RENESAS TECHNICAL UPDATE

Product Category	MPU/MCU		Document No.	TN-RZ*-A0093A/E	Rev.	1.00
Title	RZ/G2H, G2M V1.3, G2M V3.0, G2N and G2E Document Correction for DU		Information Category	Technical Notification		
Applicable Product	RZ/G Series, 2nd Generation RZ/G2H RZ/G2M V1.3, V3.0 RZ/G2N RZ/G2E	Lot No.	Reference Document	RZ/G Series, 2nd Generation User's Manual: Hardware Rev.1.10 (R01UH0808EJ0110)		
		All lots

Document correction for“RZ/G Series, 2nd Generation User's Manual: Hardware Rev.1.10”.

(3) Vertical Display Start Register n (VDSRn)

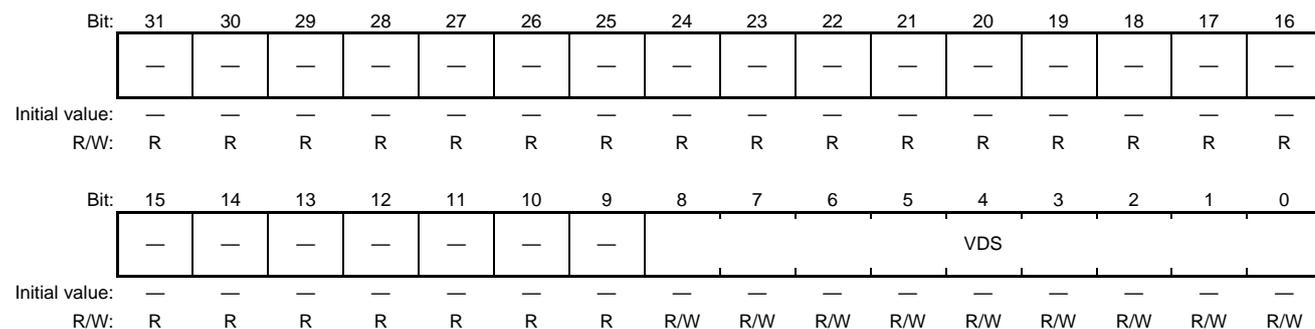
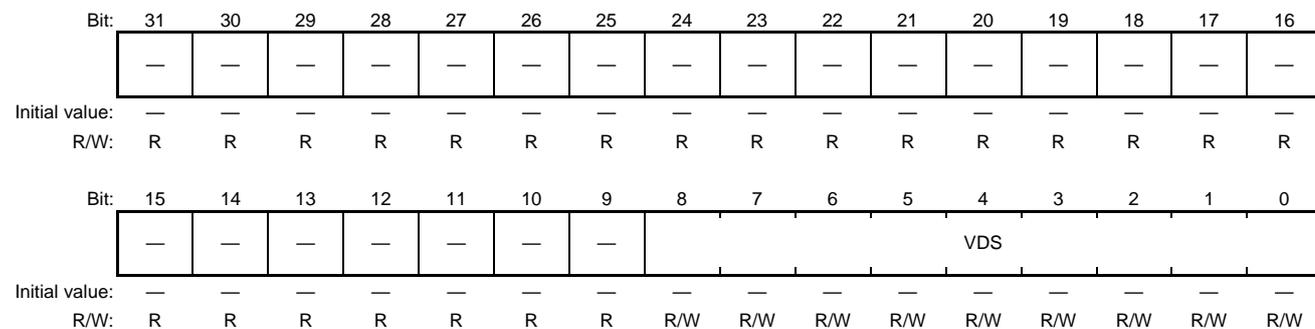
- Section 36. Booting, Page 36-81, 36.2.2 Display Timing Generation Registers. (3) Vertical Display Start Register n (VDSRn) is corrected. RZ/G2E limitation is removed.

Add Scan Mode condition to VDS restriction.

When Scan Mode is Non-interlaced mode, can be displayed even if VDS is 0.

Therefore, "VDS should be set to 1 or greater" restriction is only for Interlace sync mode (the SCM bits in DSYSRn are B'10) and Interlace sync & video mode (the SCM bits in DSYSRn are B'11).

Since RZ/G2E can only specify Non-interlaced mode, "VDS should be set to 1 or greater" restriction is out of scope.

Bit	Bit Name	Initial Value	R/W	Internal Update	Description
31 to 9	—	—	R	—	Reserved The read value is undefined. The write value should always be 0.
8 to 0	VDS	—	R/W	Available	Vertical Display Start These bits are used to set the vertical display start position in raster line units. The set value is retained at a reset. When the SCM bits in DSYSRn are B'10 and B'11, VDS should be set to 1 or greater [RZ/G2H, RZ/G2M V1.3, RZ/G2M V3.0, RZ/G2N].

Table 36.34 Correspondence Table of Settings of Display Timing Generation Registers

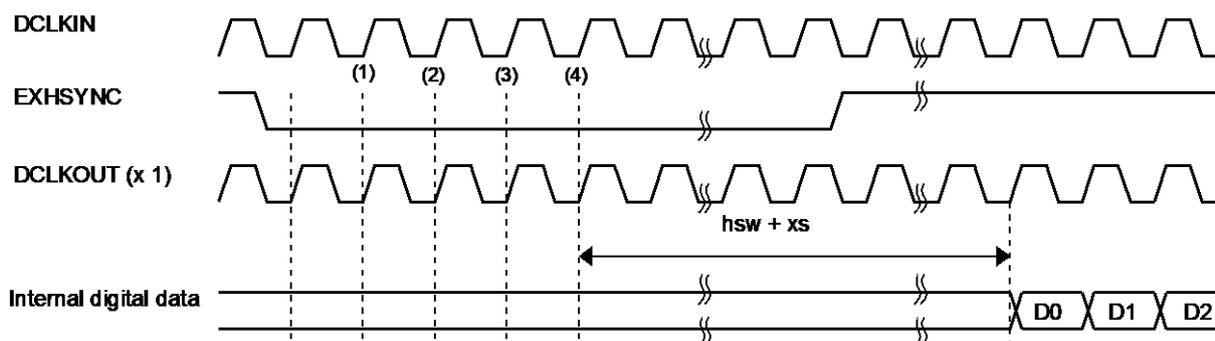
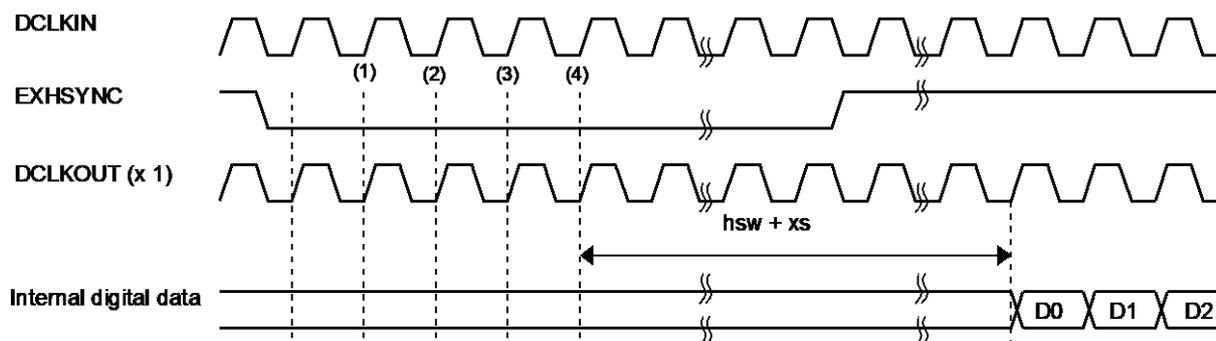
2. Section 36. Booting, Page 36-150, 36.3.10 Display Timing Generation, Correspondence Table of Settings of Display Timing Generation Registers, Note 3 is corrected. RZ/G2E limitation is removed.

Add Scan Mode condition to VDS restriction.

When Scan Mode is Non-interlaced mode, can be displayed even if VDS is 0.

Therefore, "VDS should be set to 1 or greater" restriction is only for Interlace sync mode (the SCM bits in DSYSRn are B'10) and Interlace sync & video mode (the SCM bits in DSYSRn are B'11).

Since RZ/G2E can only specify Non-interlaced mode, "VDS should be set to 1 or greater" restriction is out of scope.

- 3. When the SCM bits in DSYSRn are B'10 and B'11, VDS should be set to 1 or greater [RZ/G2H, RZ/G2M V1.3, RZ/G2M V3.0, RZ/G2N].
- 4. HC should be set so as to satisfy $HC > HDE$.
- 5. If the function below is used, the following correction value is subtracted from both HDS and HDE in Table 36.34.
- 6. HDS should be set to 1 or greater.
